Access Compliance Report

Public Rights-of-Way

Intersection ID: 3121	Main Street: MOURNING_DOVE_LN	Cross Street: ROBYNS_GLEN_DR	Location: SE
ADA ID: 145A0A2B50D5	Ramp Type: BlendTrans1	Initial Pass/Fail: Fail	Overall Compliance: No
Severity Score: 1.25			
Codes/Mitigation Info/Possible Solution		Field Measurements/Component Compliance

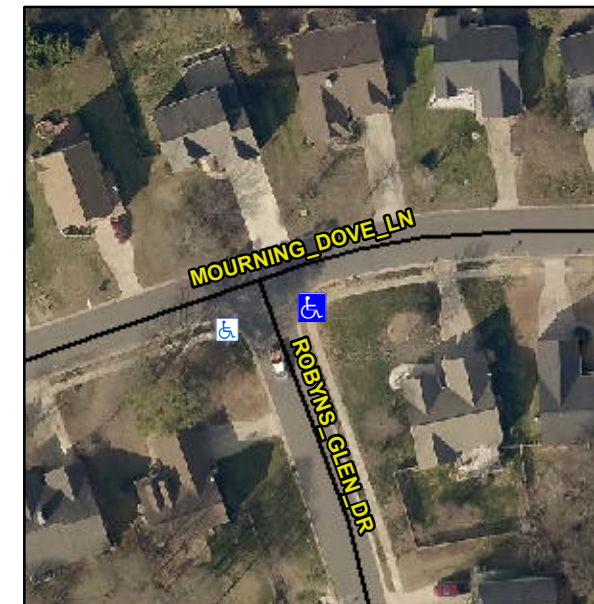
Not Found, R304.5.3

Compliance	Description	Data	Compliance	Description	Data
N/A	Ramp Length (in)	48.0	Yes	BlendTrans Slope (%)	3.3
Yes	Ramp Width (in)	84.0	No	BlendTrans XSlope (%)	4.0
N/A	Flare Type LT	N/A	N/A	Flare Type RT	N/A
N/A	Flare Slope LT (%)	N/A	N/A	Flare Slope RT (%)	N/A
N/A	Flare Traversable LT?	N/A	N/A	Flare Traversable RT?	N/A
N/A	Landing Length (in)	N/A	N/A	DWS Provided?	N/A
N/A	Landing Width (in)	N/A	N/A	DWS Contrast?	N/A
N/A	Landing Slope (%)	N/A	N/A	DWS Length (in)	N/A
N/A	Landing X Slope (%)	N/A	N/A	DWS Full Width?	N/A
N/A	Landing Curb? (Y/N)	N/A	N/A	DWS Offset (in)	N/A
N/A	Shared Landing?	N/A			
N/A	Gutter Ponding?	N/A	N/A	Gutter Slope (%)	N/A
N/A	Gutter Lip Ht (in)	N/A	N/A	Gutter X Slope (%)	N/A
N/A	Painted X Walk1?	No	N/A	Painted X Walk2?	N/A
	X Walk 1 Direction	To W		X Walk 2 Direction	N/A
	X Walk 1 Width (in)	N/A		X Walk 2 Width (in)	N/A
	X Walk 1 Slope (%)	3.1		X Walk 2 Slope (%)	N/A
	X Walk 1 X Slope (%)	0.3		X Walk 2 X Slope (%)	N/A

N/A	Ramp inside XWalk1?	N/A	N/A	Ramp inside XWalk2?	N/A
	Road Slope (%)	0.3		Clear Space?	N/A
	Road X Slope (%)	3.1	N/A	Clear Space to XWalk (in)	N/A
N/A	Any Obstructions?	N/A	N/A	Storm Grate/Utility Hazard?	N/A
	Obstruction Type			Storm Grate/Utility Type	
		N/A			N/A
			Yes	Surface Condition? (G/P)	Good
			No	Curb Slope (%)	12.9

Remove & Replace Curb Ramp With Two New Directional Ramps or Equivalent.
